Re: Erie County
Mills Street
Construction
Storm Water

June 8, 2009

On May 28, 2009, Lynette Hablitzel and I inspected the Mills Street project from 1704 Mills Street to 2211 Mills Street in Sandusky. The purpose of our visit was to evaluate compliance of the site with the National Pollutant Discharge Elimination System (NPDES) permit for storm water discharges associated with construction activity (Construction General Permit), Facility ID No. 2GC02278. The inspection was conducted under the provisions of Ohio's water pollution control statutes, Ohio Revised Code (ORC) Chapter 6111. Mr. Edward Dayringer, Engineering Technician for the City of Sandusky, was present to provide information on the project.

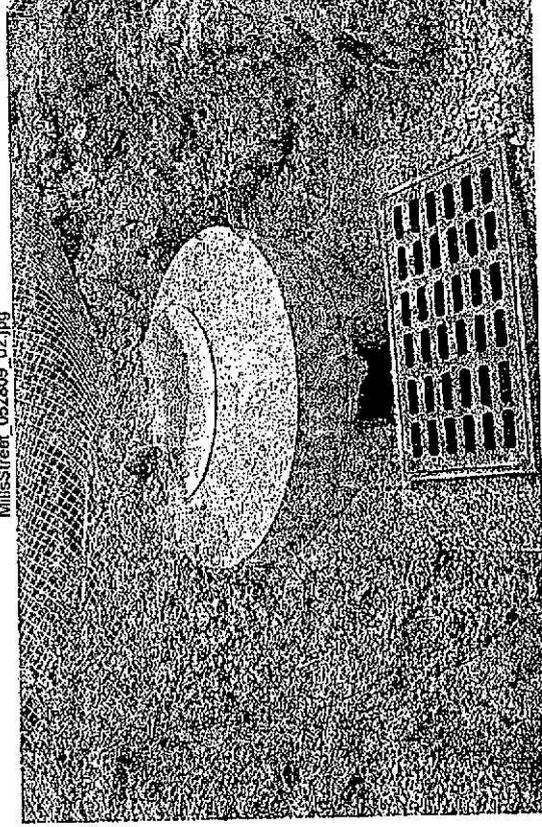
May 28, 2009, 2 PM, Mills Street, Erie County. Standing on west side of Mills St. New catch basin below grade. Hole in concrete. Edward Dayringer, City of Sandusky, stated that new sanitary and new storm sewers are separate but tributary to combined sewer. Taken by Danielle Meinenburg. MillsStreet_052809_02.jpg
